Subject: Submittal of the Work Plans for the Plugging and Abandonment of Wells and Boreholes for Fiscal Year 2019, Revision 1

**Cross-Reference of NMED NOD Comments and
Revisions to the Work Plans for the Plugging and Abandonment of Wells and Boreholes for Fiscal Year 2019**

**Response to Notice of Disapproval Work Plans for the
Plugging and Abandonment of Wells and Boreholes for Fiscal Year 2019,
Dated November 2018**

Figure 2.0-1 Locations of all wells and boreholes to be plugged

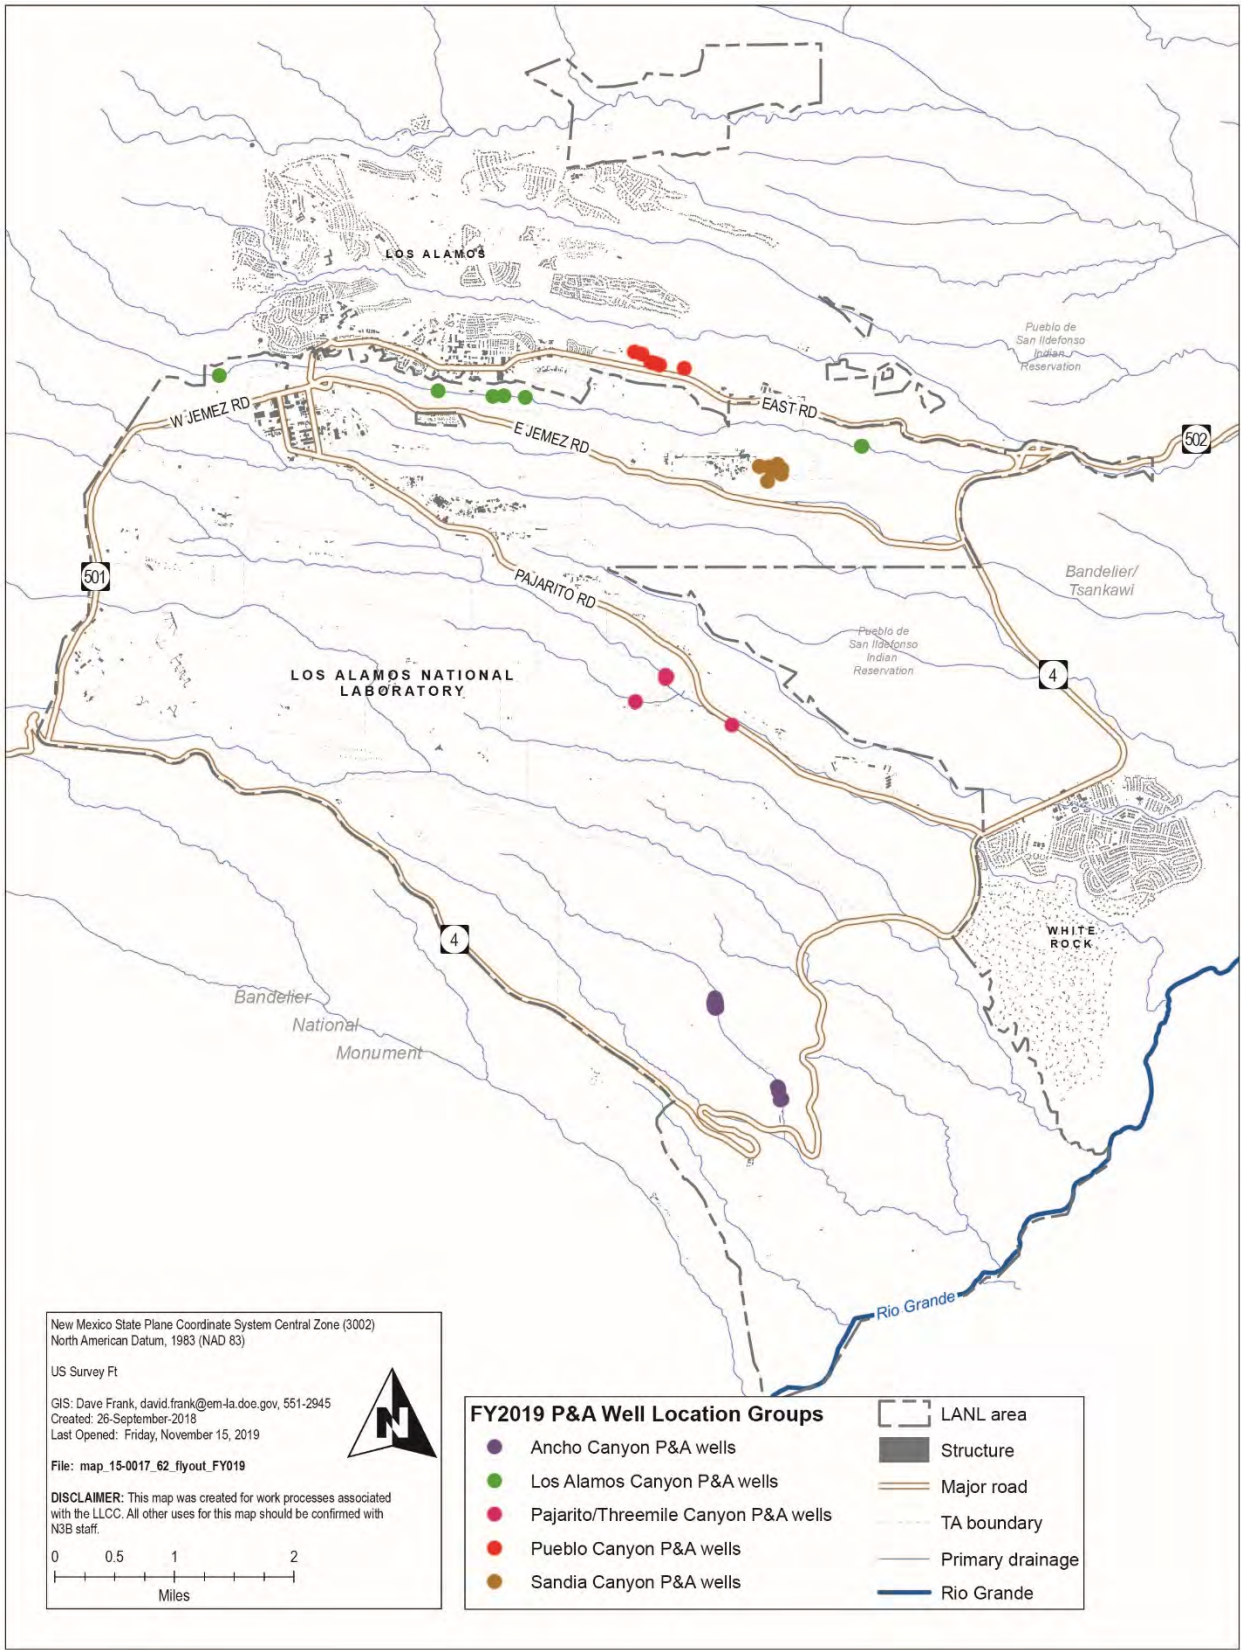
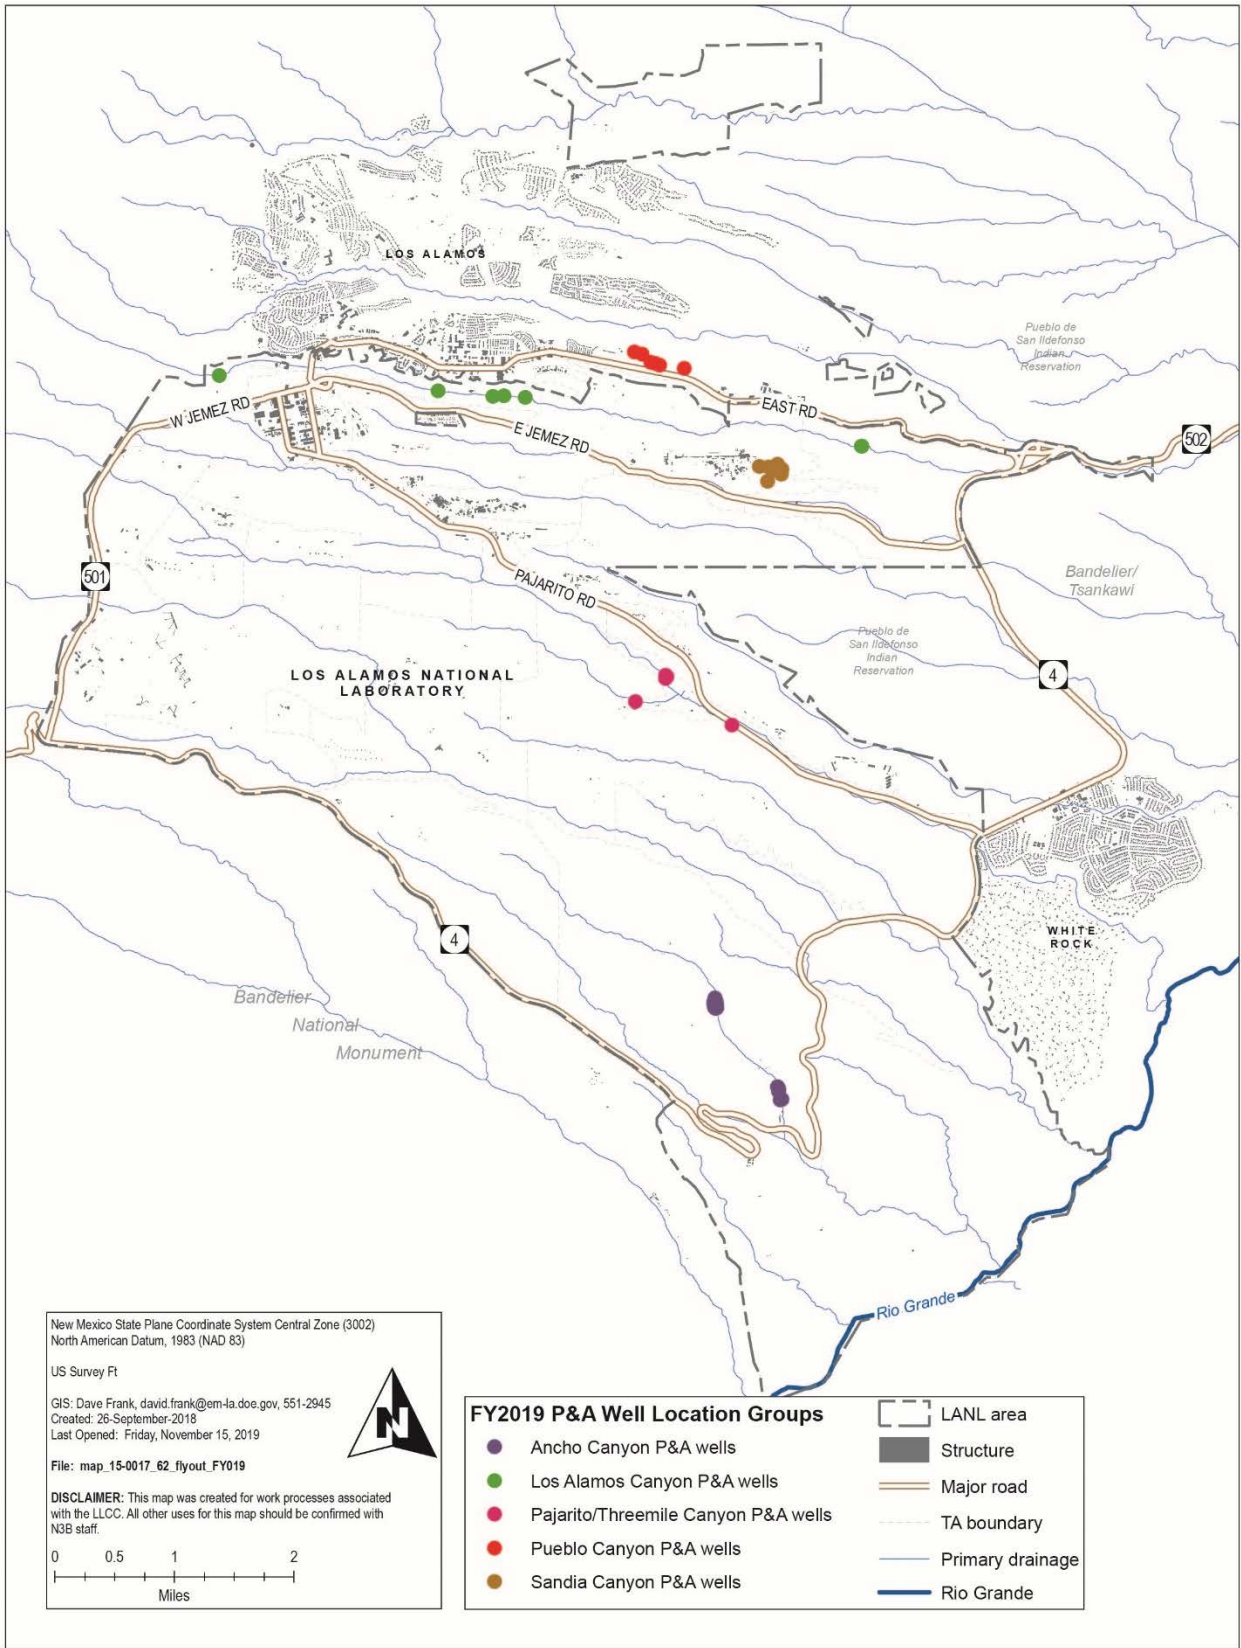
3. ***The following wells (which are designated for plugging and abandonment in the Work Plan) must be retained for future monitoring, assuming they are currently functional or can be repaired: LAO-0.6, LAO-1.6g, LAO-6A, 18-MW-7 and 3MAO-2. DOE must remove these wells from the Work Plan.***

3. The five wells that were required to be retained by NMED for future monitoring have been removed from this work plan.

Of the 50 wells planned for plugging and abandonment activities in the original work plan, 5 have been removed from this revised work plan. These five wells are LAO-0.6, LAO-1.6G, LAO-6A, 18-MW-7 and 3MAO-2. The New Mexico Environment Department (NMED) required that these 5 wells be retained for future monitoring.

The locations of all wells and boreholes currently planned to be plugged and abandoned starting in fiscal year 2023 are shown in Figure 2.0-1. Each well or borehole will have its own completion report. The delivery date of each field completion report is scheduled for 120 days following abandonment activities for the associated well. Background information on the installation of these wells and the rationale for plugging and abandoning each group is provided below.
